Agenda
Zoning Board of Appeals
Wednesday, November 29, 2017 - 7:00 P.M.
City Hall-Council Chambers, 1 S Huron St
Ypsilanti, MI 48197

**Staff Review of Variance Application
Pearl Street Fourplex driveway
708 Pearl**

Regarding: 708 Pearl Street Fourplex
Variance Request
OHM Job No. 0094-17-1040

Regarding: 708 Pearl Street Fourplex
Site Plan Review No. 1
OHM Job No. 0094-17-1040

TITLE: **SITE PLAN**

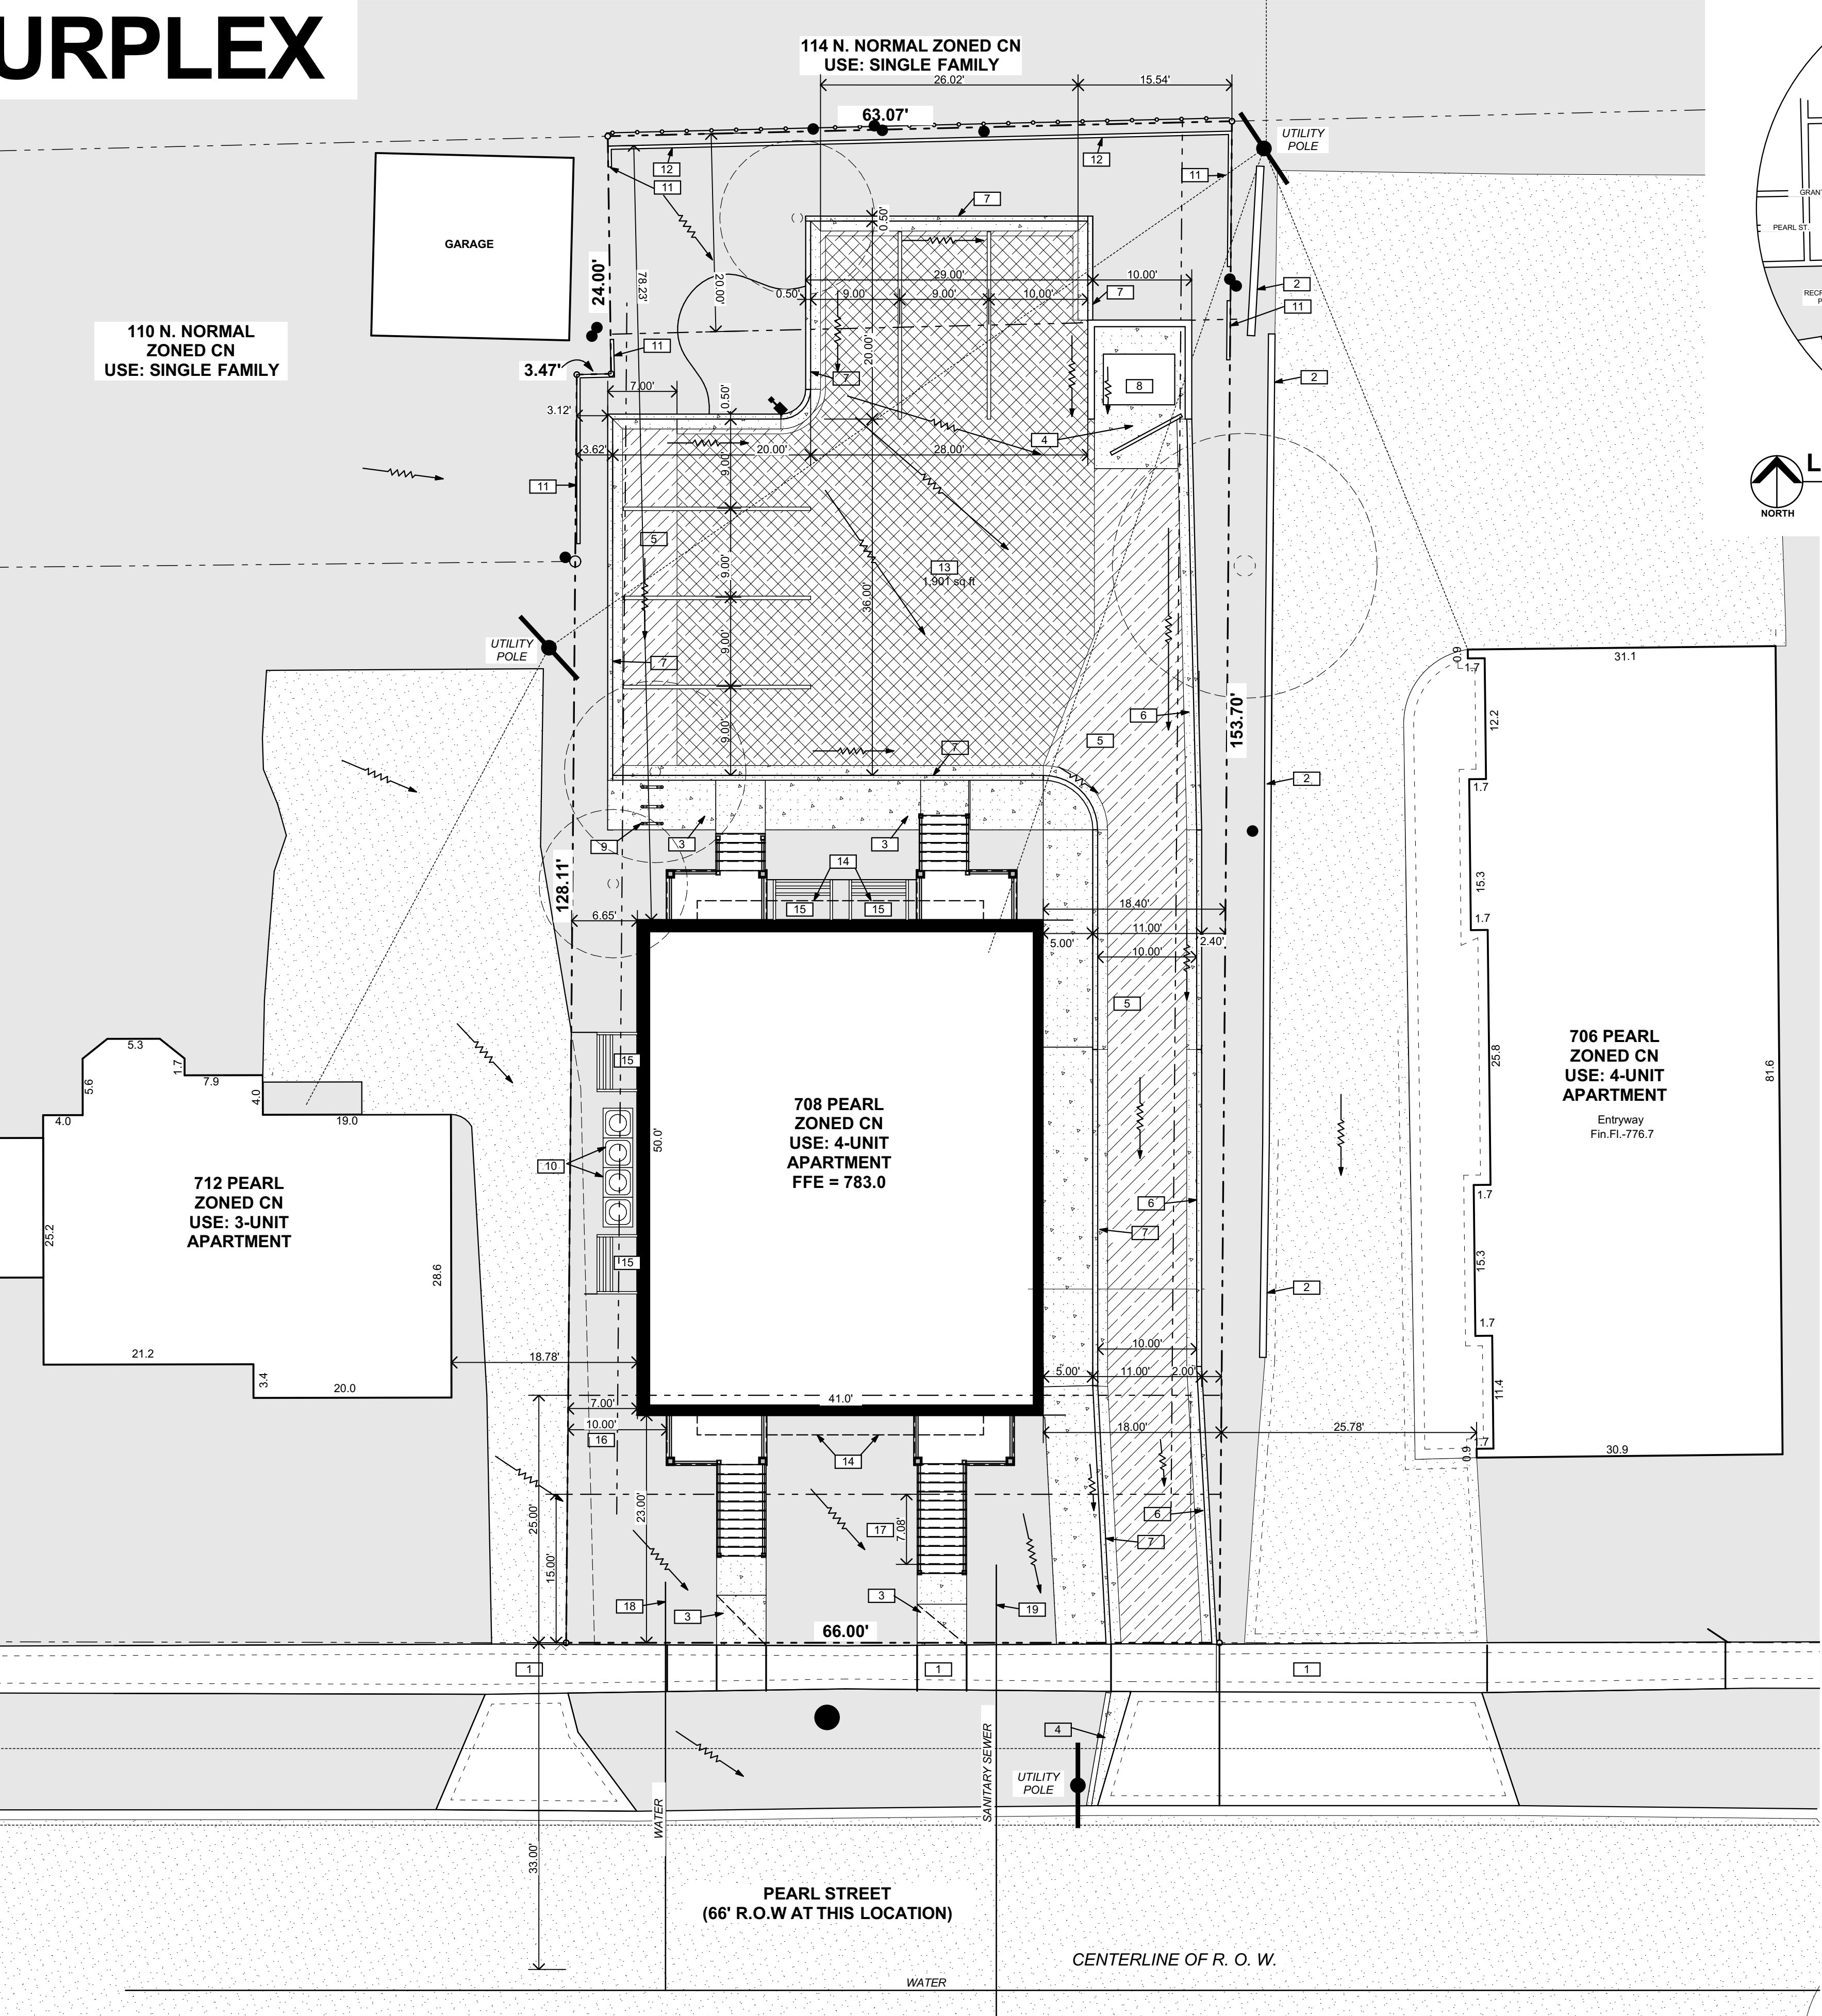
The applicant has proposed a one way drive at 10' instead of the 20', or two -way drive required by the zoning ordinance in §122-683(b) for ingress and egress. The plans originally submitted to the Planning Commission had a 13' wide drive without an access path, which is required by the zoning ordinance. Staff and the Planning Commission required the driveway width, which was already not large enough to accommodate two way traffic, to be decreased to accommodate a 5' access path.

The applicant notes that practical difficulty is found in attempting to add a 20' drive on the lot due to the narrowness of the property and the location of the existing utility pole. The site plan indicates that the frontage on the lot is 66' and the lot narrows to 63.07' at the rear; this amount is similar to other lots in the area. It is unclear as to whether or not the applicant has attempted other options in regards to site and building layout. However a an increase in the driveway width with a corresponding reduction in the width of the structure would mean that the frontage build out requirements of 60% to 80% for the apartment house building type would no longer be met.

As the variance is only for the driveway width it is not expected that the granting of this variance will be detrimental to the public welfare or injurious to other property or improvements in the neighborhood. However it could create potential issues for access to and from the parking lot for residents of the property. Signage and/or a mirror would be required for safe usage of the drive as proposed.

It is unclear if other options were explored by the applicant in regards to site layout such as a joint driveway on the west side of the property. Nevertheless, a 10' drive is reasonable considering the zoning requirements for frontage, pedestrian access and setbacks.

1. The one-way drive is justified based on the low trip generation from the proposed development. The proposed drive meets the minimum width requirements for a one-way drive.
2. The available drive approach locations are constrained by the existing drives on the parcels on both sides of the subject parcel and the location of existing utility poles. The proposed location of the drive approach utilizes a shared approach with the property to the east and avoids the utility pole conflict.

1. The access driveway for the parcel to the west encroaches the subject property. It appears the applicant is proposing to maintain this access unchanged. If this is the intent, an access easement shall be recorded.

2. The applicant shall review Division 7 section 122.683 of the Zoning Ordinance and the City of Ypsilanti Engineering Standards for parking and drive requirements. The project as proposed does not meet the requirements for drive offset from the property line or minimum drive width. A variance will be required for the drive as proposed. It appears a reduction in the required drive width may be appropriate for the development in order to be consistent with the surrounding properties. The drive connection to Pearl Street could be greatly improved if the existing utility pole were relocated.

4. The plan also proposes sheet drainage into the right-of-way for the driveway. This is prohibited per Division 7 section 122.683 (f) of the Ordinance. A variance is justified in this case due to the fact that there is no underground storm sewer available for connection on this block.

Staff recommends the Zoning Board of Appeals *deny* the variance request to permit a one-way driveway with a 10' width at 708 Pearl, with the following findings:

1. The alleged practical difficulties on which the variance request is based have in part been created by a person presently having an interest in the property under §122-370(b)(3).

Based on the material presented the variance request is justified from an engineering perspective.
